Docket Item #8
BAR CASE #2010-0320

ISSUE: Door Replacement

LOCATION: 708 Duke Street

The applicant is requesting approval of a Certificate of Appropriateness for a replacement door at 708 Duke Street.

Figure 1: Existing Conditions Photos

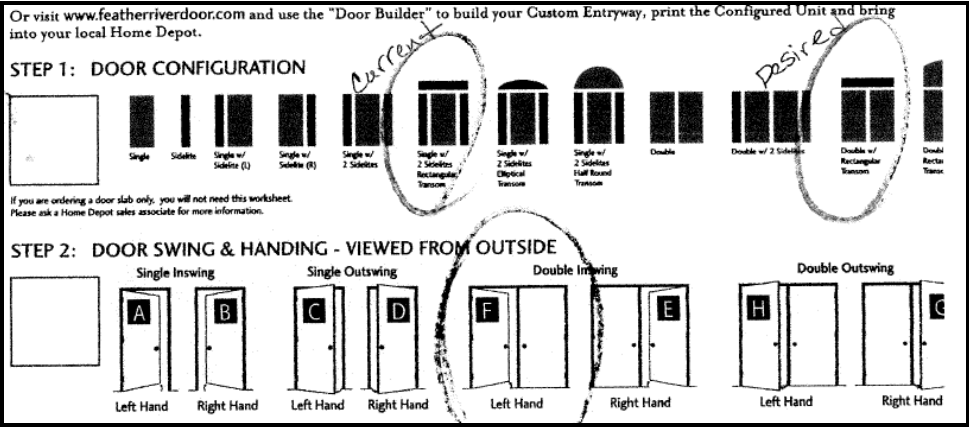
The applicant is requesting approval of a replacement front entry door. The existing front door is a traditional four paneled wood door flanked by full-length sidelights to be replaced with a set of Feather River, factory-painted, fiberglass, six-paneled doors. The existing storm doors will be removed and not replaced.

The application as currently presented is requesting that the Board approve replacement of the current four-panel, wood, door flanked with full sidelights with a set of new fiberglass, six-panel doors. The applicant has indicated that the existing single door causes difficulty maneuvering around the stair immediately inside and this would move the active leaf of the pair of doors away from the stair. Double door, often containing glass upper panels, were common on Victorian period buildings and Staff has no objection to alteration of this entrance to accommodate the proposed pair of doors. However, as this building was built in the neo-Victorian style in the late 1980s, staff would recommend that the proposed doors retain the four-panel configuration, either with or without

That the new fiberglass doors are a pair of four-panel doors ordered unfinished and painted on-site.

Figure 2: Proposed Door to Be Installed

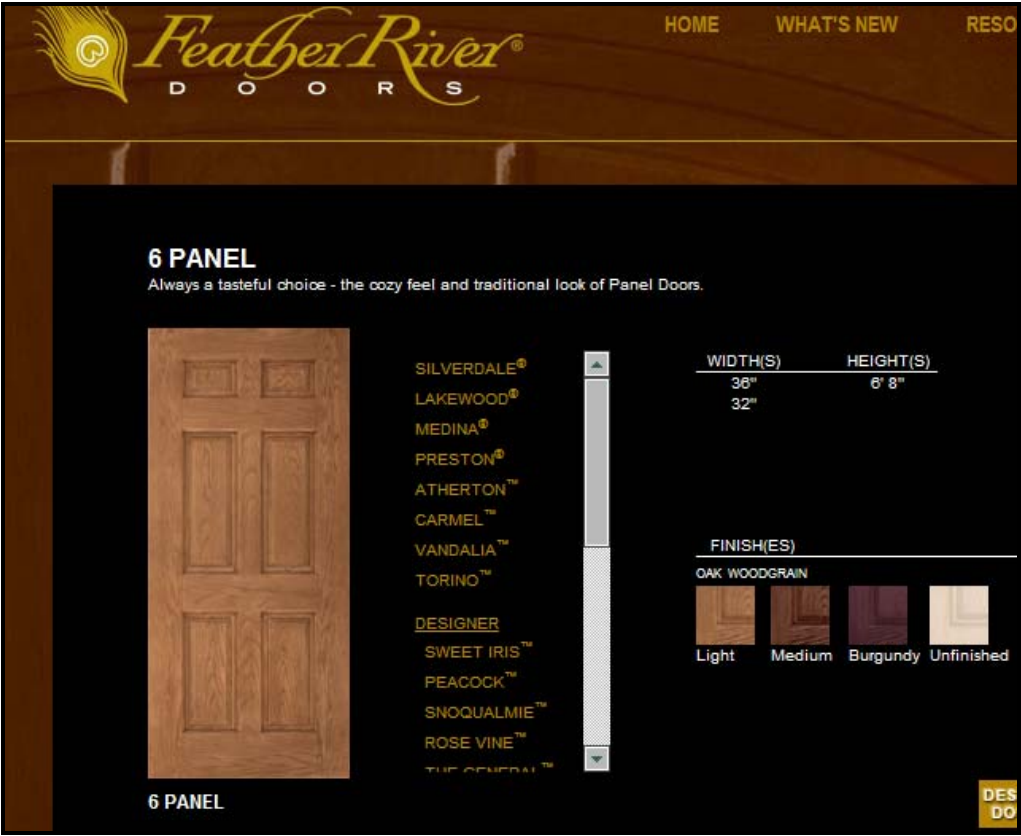
A roof materials policy and a windows policy were adopted at the October 27, 2010 hearing to assist in the Certificate of Appropriateness and Administrative Approval processes and to supplement the existing *Design Guidelines*. In the coming months, Staff will be exploring small alterations to some of the Board's other policies. One such alteration includes revisiting the Board's policy on doors on modern buildings within the historic district. It has been the Board's current practice to only approve wood doors on modern buildings within the historic district. Staff would like feedback from the Board on whether the *Design Guidelines* might be amended to allow high-quality, field-painted fiberglass doors on modern buildings within the historic district to be approved by staff at an administrative level. Invented in the mid-1960s, modern fiberglass doors have evolved to include details such as solid square edges, architecturally correct stiles, rails and panels. In addition, many companies provide the option to order the doors unfinished in order for the door to be field painted.
